MEMO

To: Kristopher Byrd, Well Construction and Compliance Section Manager
From: Travis Kelly, Well Construction Compliance Coordinator
Subject: Review of Water Right Application G-19198
Date: March 1, 2022

Groundwater Application Review Summary Form

Application # G- 19198

D2. **THE WELL does not appear to meet current well construction standards based upon:**

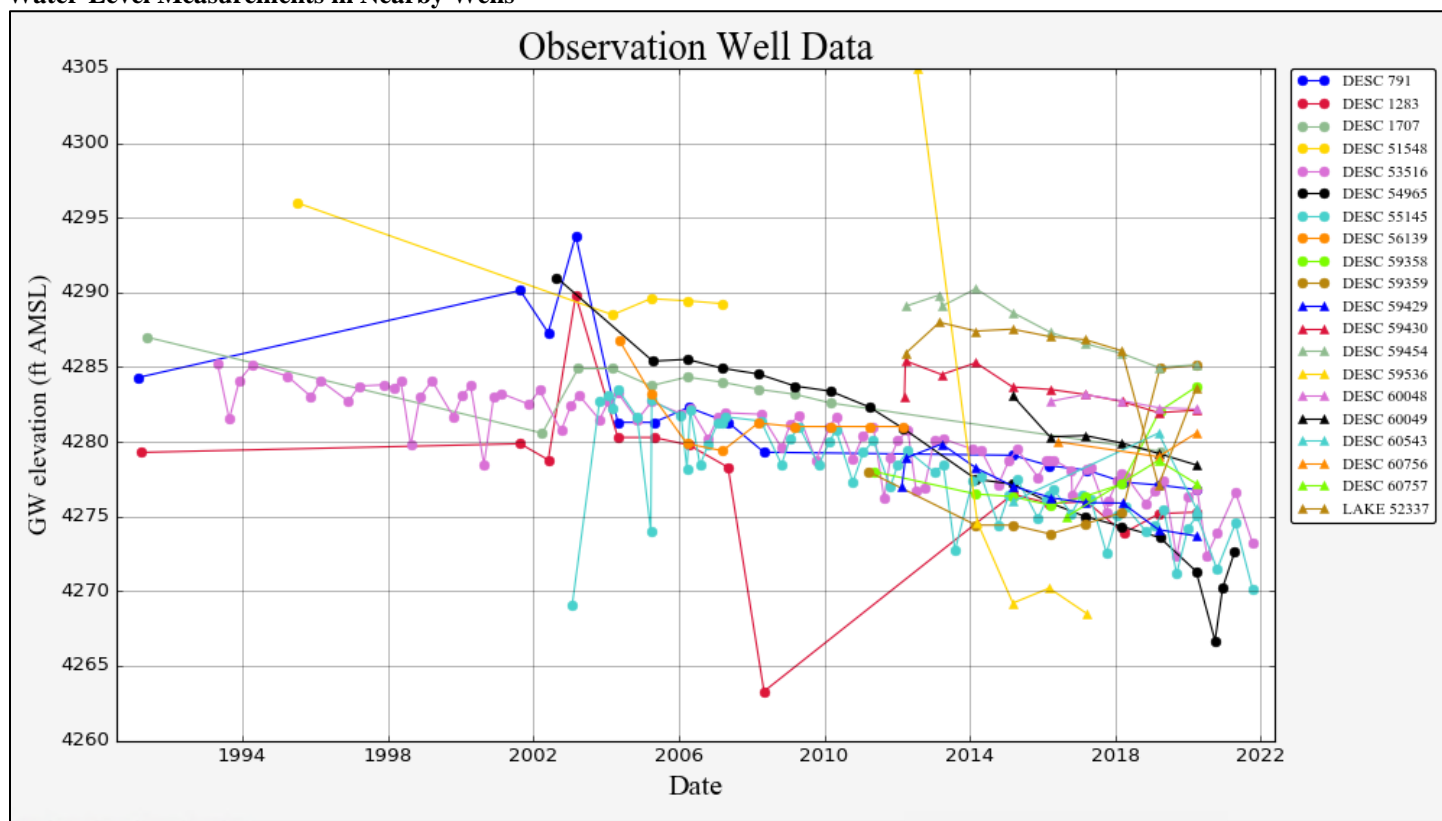
Applicant's Well #1 (DESC 60049): Based on a review of the Well Report, Applicant's Well #1 does not appear to comply with current minimum well construction standards (See OAR 690 Division 210). The problem is that according to the Water Supply Well Report, the well was not sealed to the proper depth. In order to meet minimum well construction standards, the well must be resealed with an approved grout to a minimum depth of 114 feet below land surface.

- a. review of the well log;
- b. field inspection by _____;
- c. report of CWRE _____;
- d. other: (specify) _____

My recommendation is that the Department **not issue** a permit for Applicant's Well #1 unless it is brought into compliance with current minimum well construction standards or information is provided showing that it is constructed to meet current minimum well construction standards.

D4. **Route to the Well Construction and Compliance Section for a review of existing well construction.**
